# Bexley TLC

Landscape Strategy - Rev D

## KEY DIFFERENCES IN UBU PROPOSALS

## Previous Approved Scheme

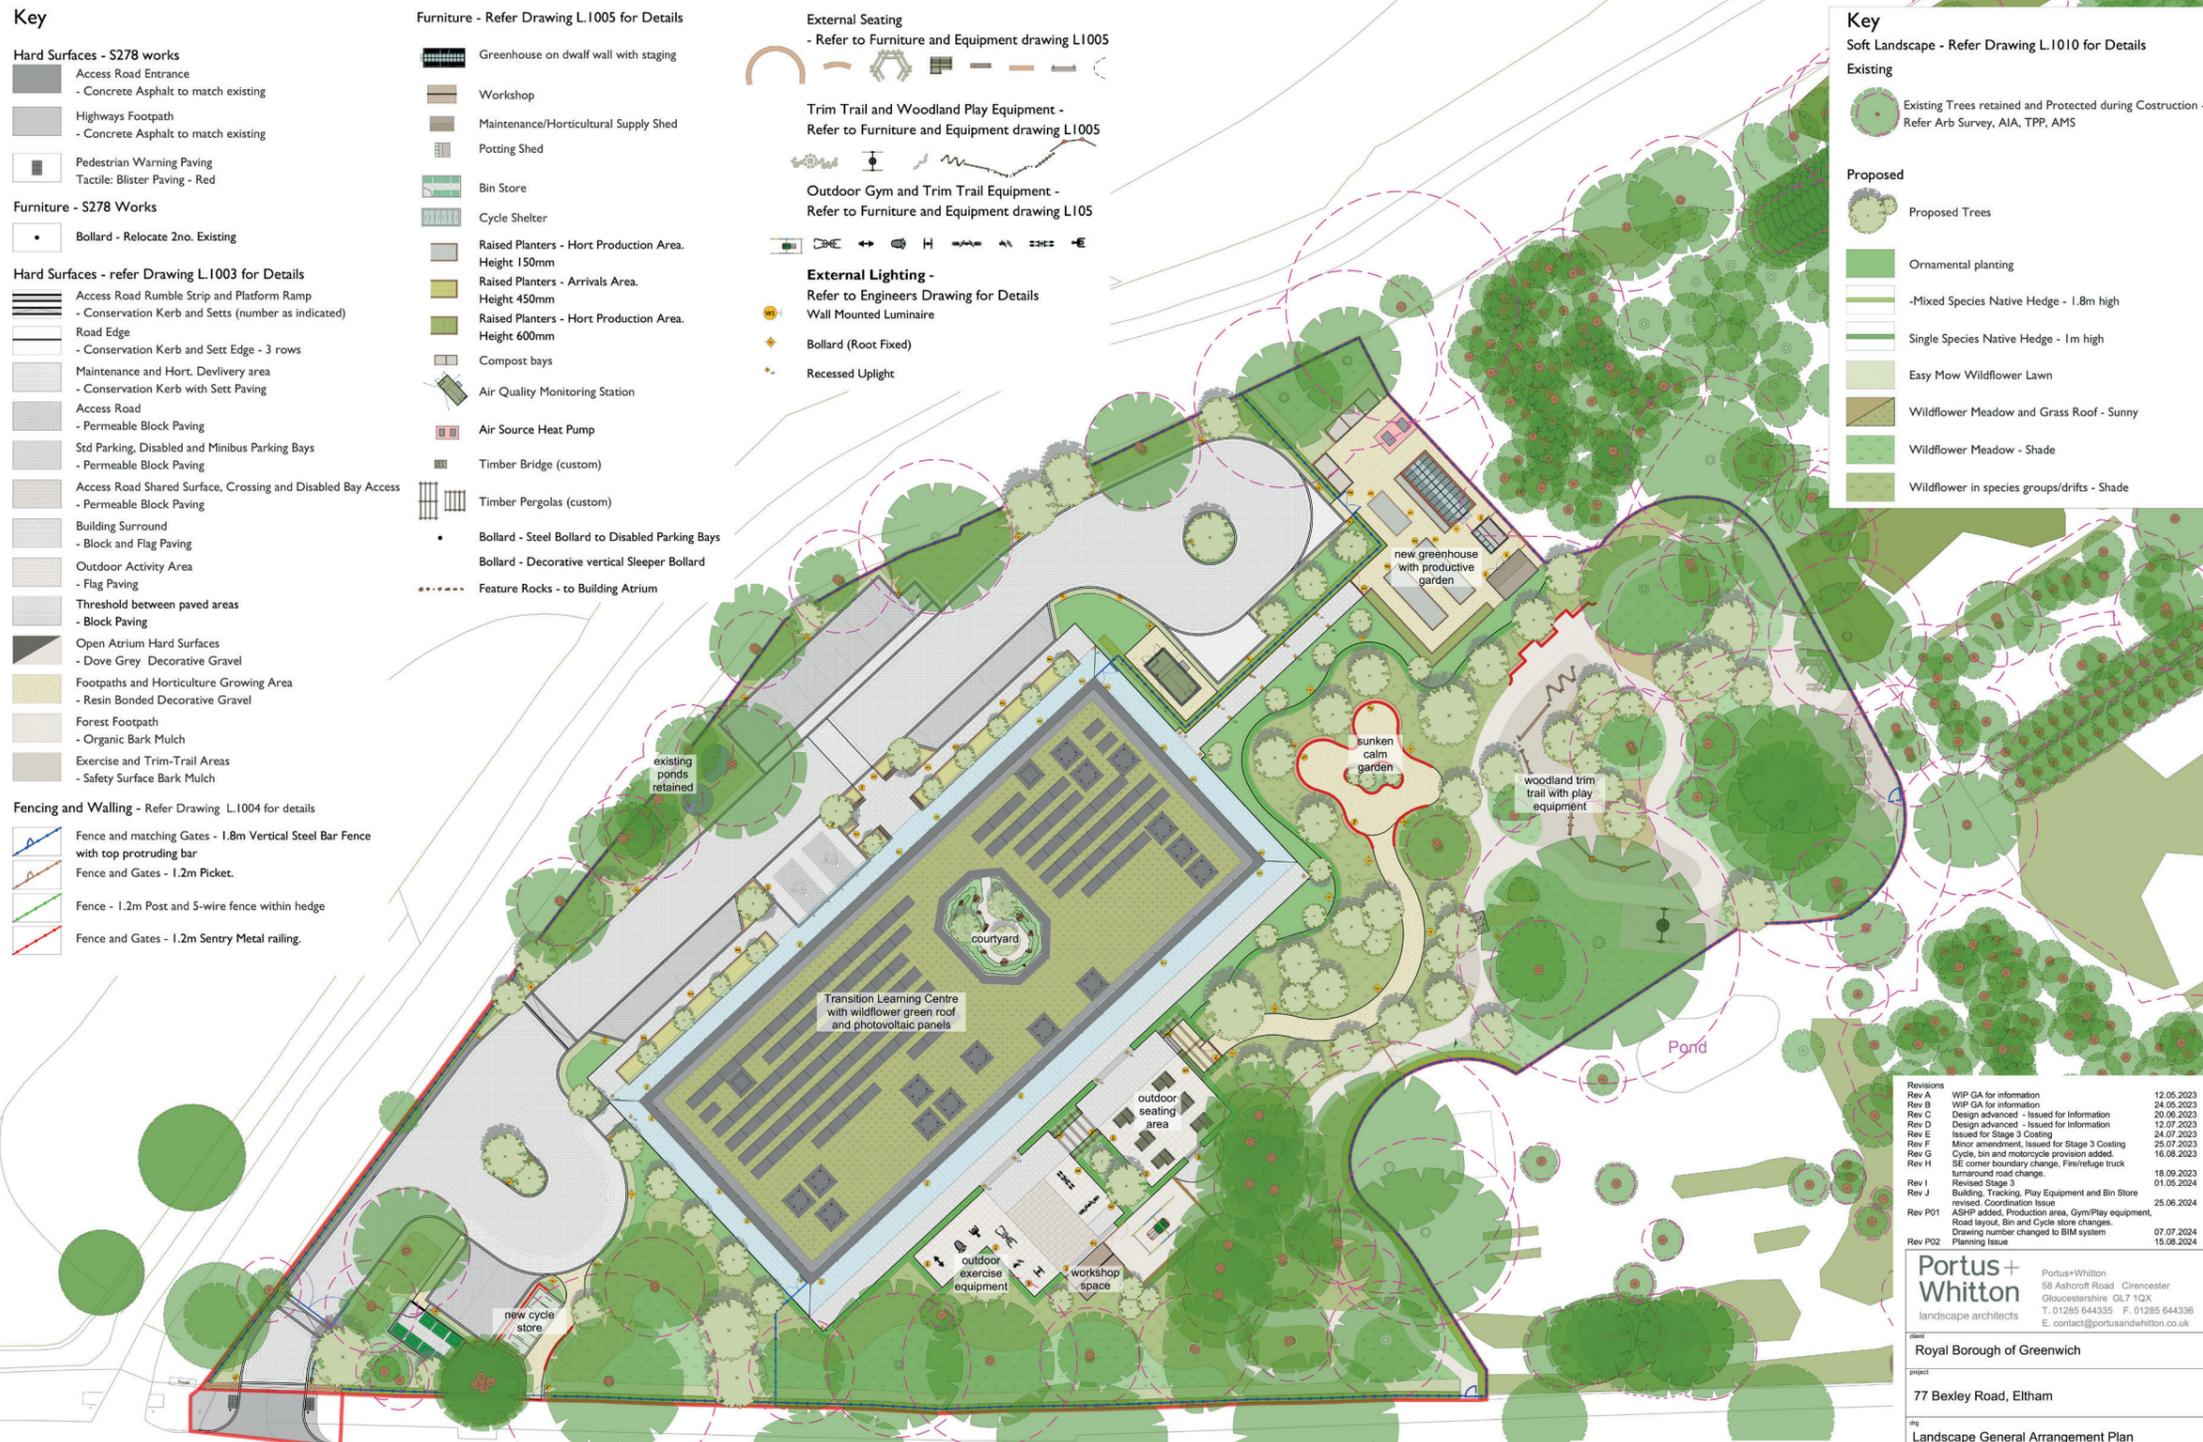
- 01 Road changed from paving to tarmac with standard kerbs
- 02 Reduced areas of hardscape in scheme
- 03 Simplified spec of materials in scheme
- 04 Reduced parking in scheme ( 2 bays)
- 05 Reduced fencing in scheme including metal railings and picket fence
- 06 Reduced furniture in scheme including trim trail, play equipment, seating and pergolas
- 07 Replacement of bark mulch areas with planting in woodland areas
- 08 Omission of atrium courtyard
- 09 Reduced tree and hedge planting
- 10 Only 1 turning head provided
- 11 Wildflower areas replaced with lawn
- 11 Levels rationalised through graded landscape - approved scheme would require extensive retaining features
